T7 PCI-EPP CONVERSION FIELD UPGRADE PROCEDURES (MODELS RL/FT5000/RL/RT2000)

TDN 07103-00184 REV B 08/2008

T7 PCI-EPP CONVERSION PROCEDURES

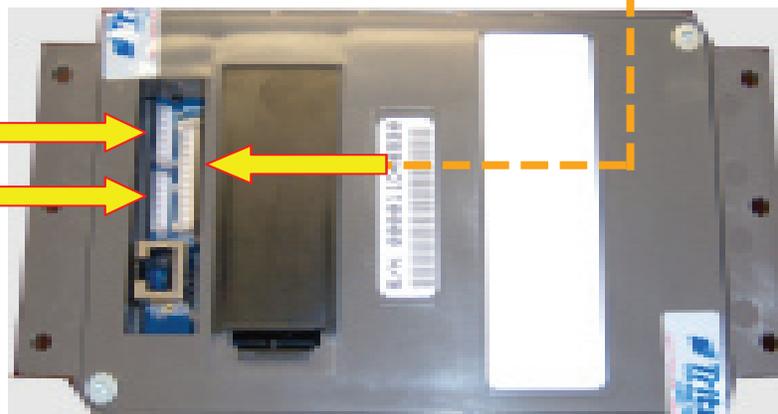
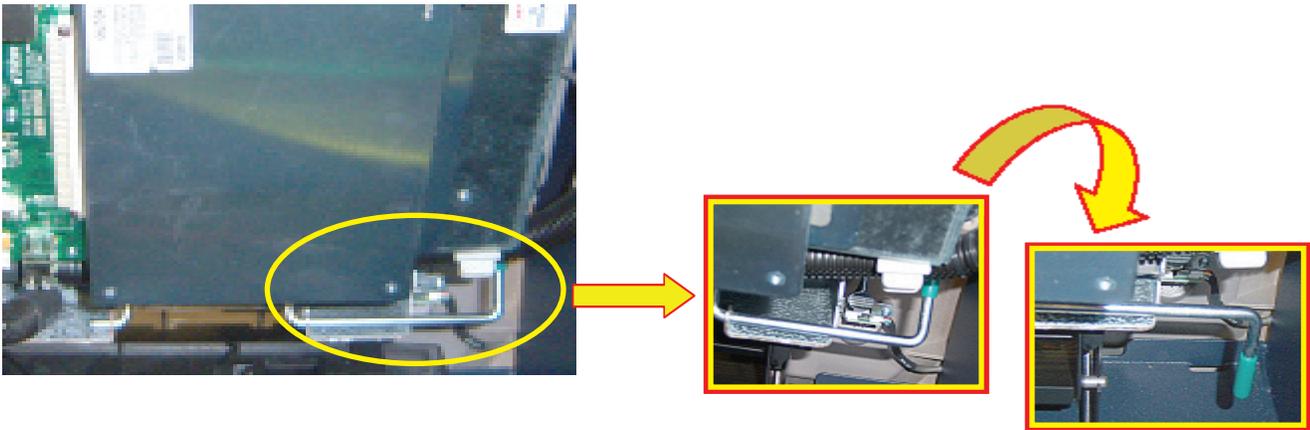
The T7 PCI-EPP is a drop-in replacement for any existing T1 (VEPP) or T5 (PCI-EPP). It accommodates the existing two (2) Function key cables for the T1 or the single Function key cable employed by the T5 (PCI-EPP), as well as the RJ45 Data cable. Refer to the pictures below for cable connectivity.

- Disconnect the existing cables from the EPP (keypad).
- Remove the six (6) screws (phillips-head) that secure the keypad. Remove and replace the keypad with the T7.
- Secure the T7 WITH THE SIX (6) SCREWS INCLUDED IN KIT (K40x20, PT FASTENER SCREW).
- Reconnect the function key cable(s) and data cable to the T7.

NEW K12000 EPP mounting bracket

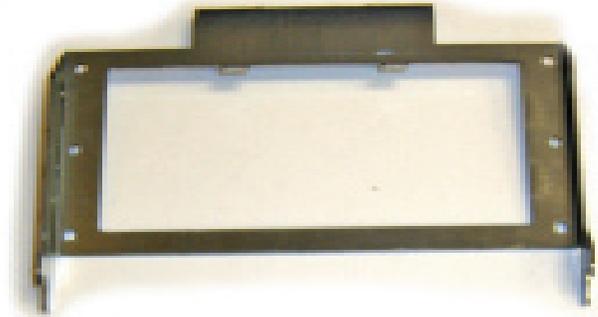
➤ Place the EPP assembly on a flat surface. Remove the six (6) screws/nuts that secure the EPP to the mounting bracket. Retain the screws and cable guide. Both the T7 (PCI-EPP) and the T5 (PCI-EPP) require this new bracket (included in kit) when installed in the RT2000.

- Mount the new SPED bracket to the T7 (PCI-EPP) as shown below. Secure with the six (6) screws previously removed from old assembly. Remember to reinstall the cable guide.
